SERVICE BULLETIN

M-850

SAFETY RECALL CODE 055

4-SPEED TRANSMISSION — 1982 FL/FX MODELS

Figure 1. Checking Transmission for 055

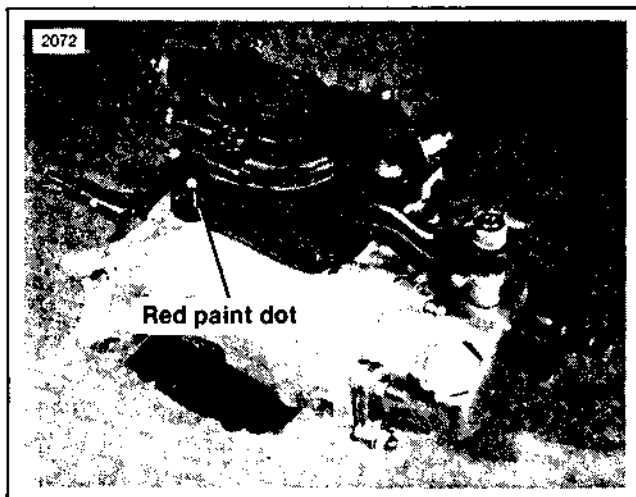
1. All Code 054 replacement transmissions shipped from the factory after January 18, 1982 have already been inspected and serviced for 055. Examine the clutch release arm (see Figure 1). If a red paint mark is present on the end of the arm as shown, no further inspection is required. Submit a Code 055 Dealer Service Card marked "N" in the Code Box and "O" in the Quantity Box.

If no red mark is present, proceed to Step 2.

Figure 2. Testing the Bearing Hardness

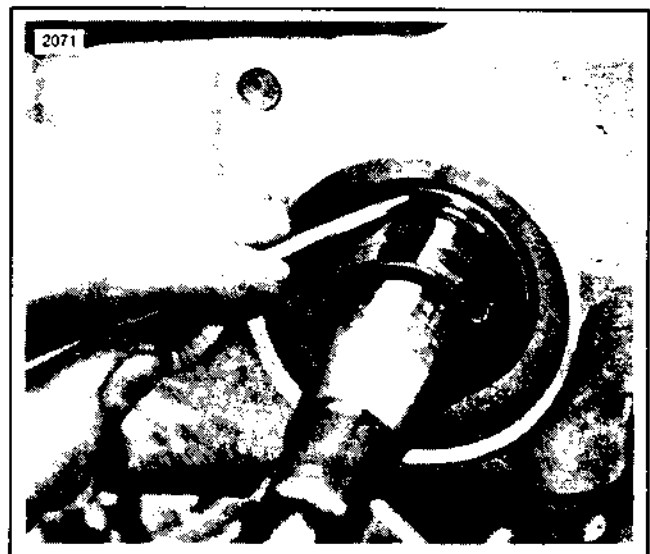
8. Remove the oil seal and discard.
9. Remove the spacer to reveal the bushing and bearing end face.
10. Clean the bearing end face with solvent.
11. See Figure 2. Using a scribe, awl or other suitable sharp instrument (not carbide), attempt to scratch the face of the bearing as shown. Do not attempt to scratch the bushing or bearing face area where the numbers or letters are stamped.

12. If you are able to scratch the bearing surface, the bearing **IS NOT hard** and the transmission must be replaced. If you cannot scratch the bearing surface, the bearing is hard and transmission replacement is not necessary.
13. After performing the test procedure, determine if the vehicle is also involved in the 054 recall campaign by checking the VIN and transmission number lists provided with Service Bulletin M-847.
14. Determine which of the following categories the vehicle falls into, then refer to the appropriate chart attached to this bulletin and perform the necessary service.
